Modification Application - Regulation 22

Interest Holder	Central Petroleum Limited	EMP Title	NT Drilling Campaign	Unique EMP ID No.	CTP 3.4	Mod No.	2	Date	10 March 2021
Brief Description	<p>The NT Drilling Campaign EMP was approved by the minister on 29 November 2020. The plan included the development of well pads, access tracks and the associated infrastructure necessary to drill 2 development wells (WM27 and WM28) at Mereenie.</p> <p>In relation to the WM28 well, Central would like to modify the access track route to the well pad as approved in the EMP. The modification is necessary as Sacred Site Clearance Certificate (SSCC) (C2020-009 - Appendix A) issued on 23 February 2021 by the Central Land Council (CLC) required under our land access agreement differs from the authority certificate (C2020/084 - Appendix B) granted on 25 November 2020 by the Aboriginal Areas Protection Authority (AAPA).</p> <p>A variation to the approved authority certificate (C2020/084) has been lodged and is being processed by the Aboriginal Areas Protection Authority (AAPA). However, if this approval is not granted prior to the well pad needing to be developed an alternative access route will be needed.

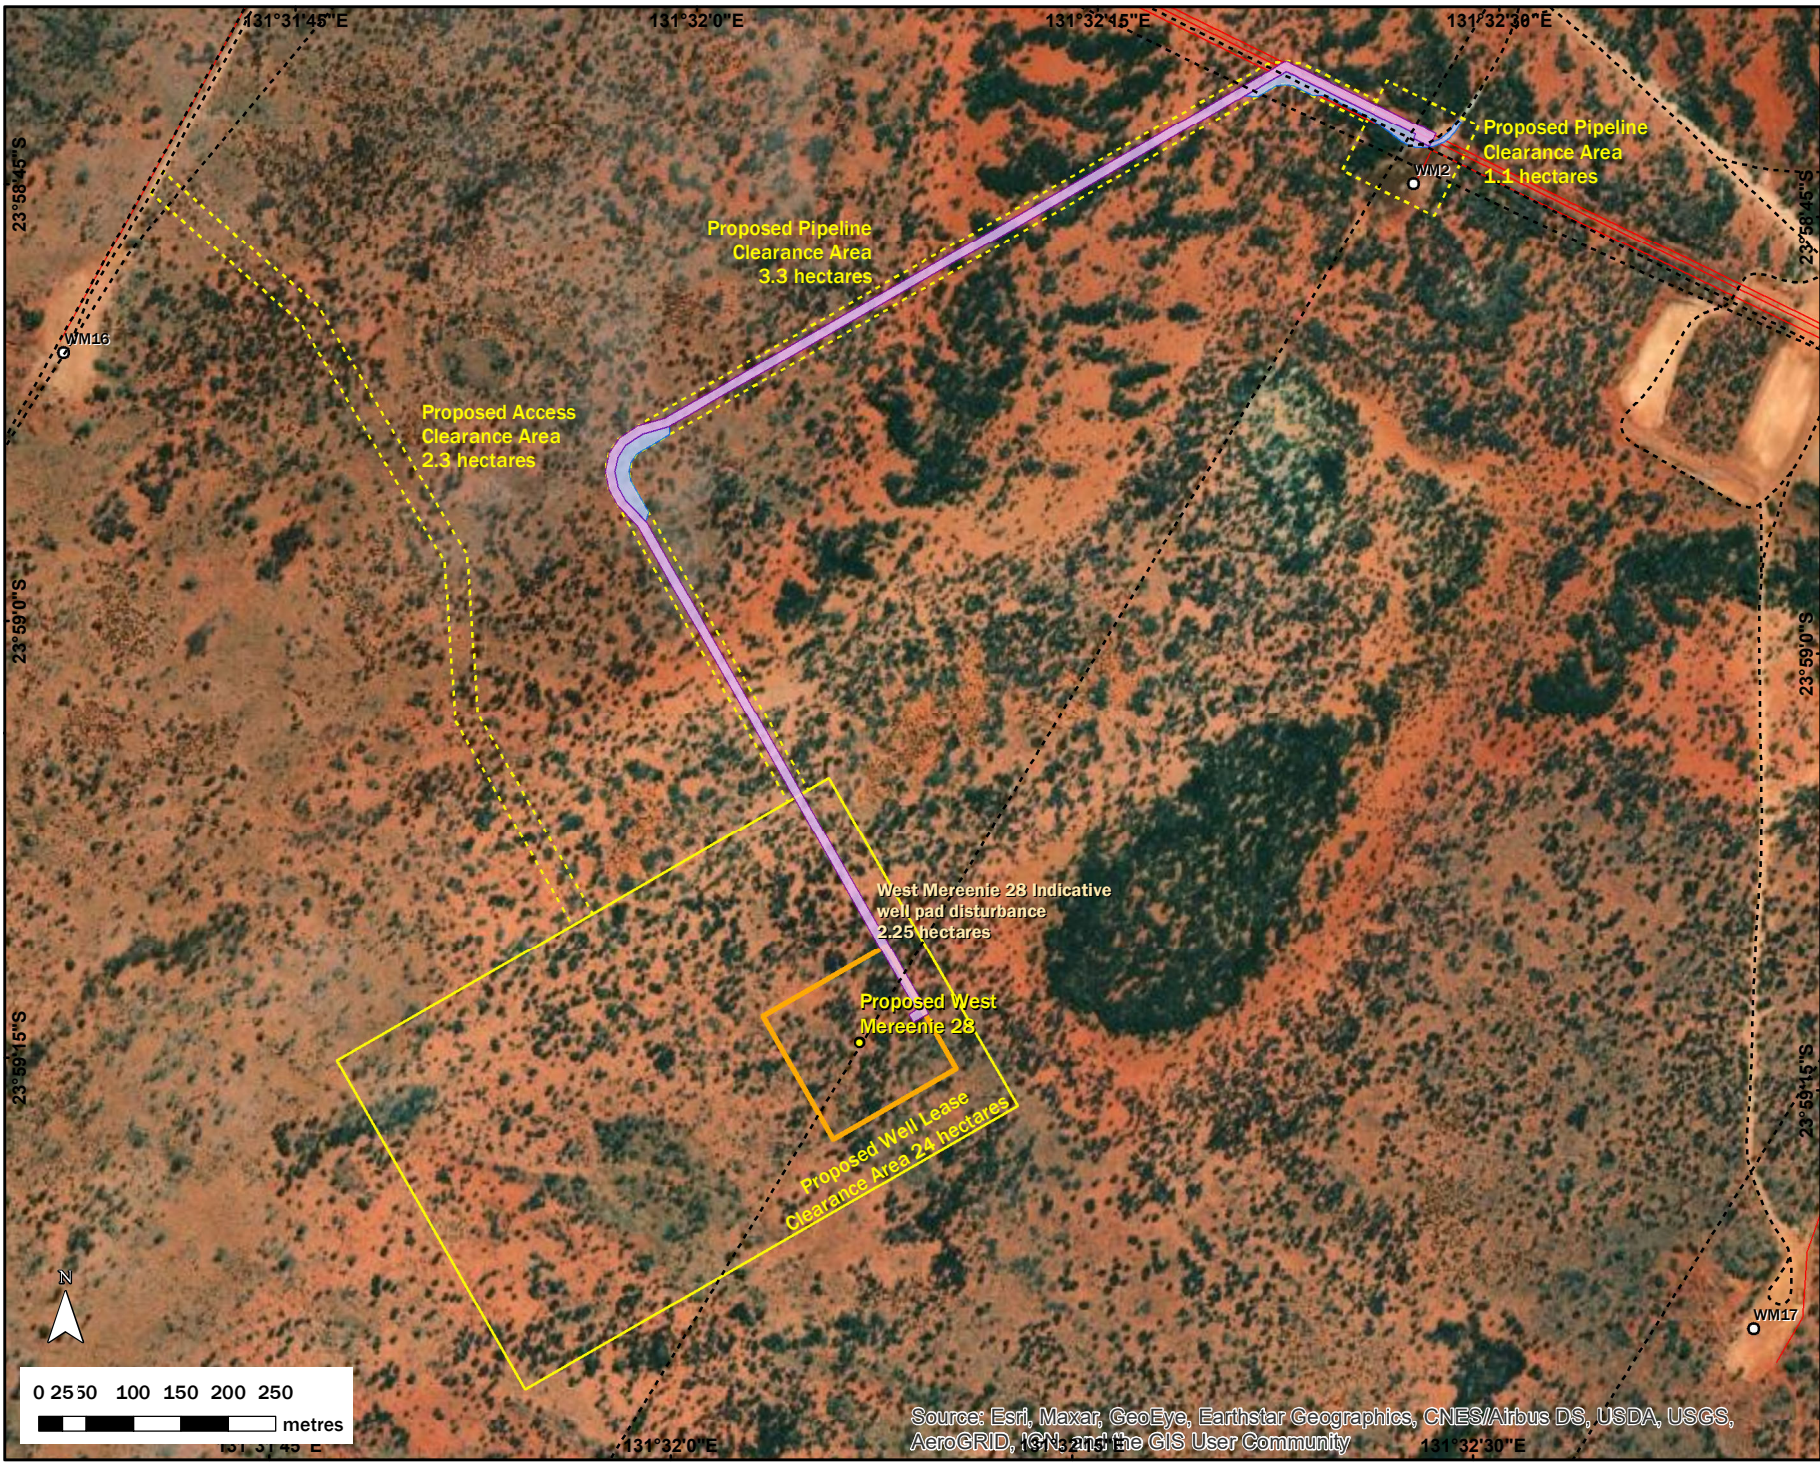
<p>Figure 4-3 – Clearance Area (West Mereenie 28 Well)</p>	<p>Figure 4-3 – New Clearance Area (West Mereenie 28 Well)</p> <p>This figure has been updated to highlight the use of the ROW as the new access track route / location to the WM-28 well (Appendix C). The new route has been cleared by the CLC and AAPA.</p>
<p>Figure 5-15 Land Types (West Mereenie 28 Well)</p>	<p>Figure 5-15 Land Types (West Mereenie 28 Well)</p> <p>The ROW highlighted on this map will be used access track. A small amount of additional clearing highlighted in blue (Appendix C) may be needed. The new route along the ROW has been cleared by the CLC and AAPA.</p>
<p>Risk Register – Failure of flow lines</p> <p>Aboveground Flowlines</p> <ul style="list-style-type: none"> West Mereenie wells - the flowlines are not co-located with the access track to decrease likelihood of accidental vehicle damage (engineering) 	<p>Risk Register – Failure of flow lines</p> <p>Aboveground Flowlines</p> <ul style="list-style-type: none"> West Mereenie 27 well - the flowline is not co-located with the access track to decrease likelihood of accidental vehicle damage (engineering) West Mereenie 28 well - the flowline is co-located with the access track to facilitate a drill rig move. The line will not be live at any time during well pad development, mobilisation, drilling and demobilisation when the right of ROW would be used. Therefore, the likelihood of any release as a result of accidental vehicle damage is zero.
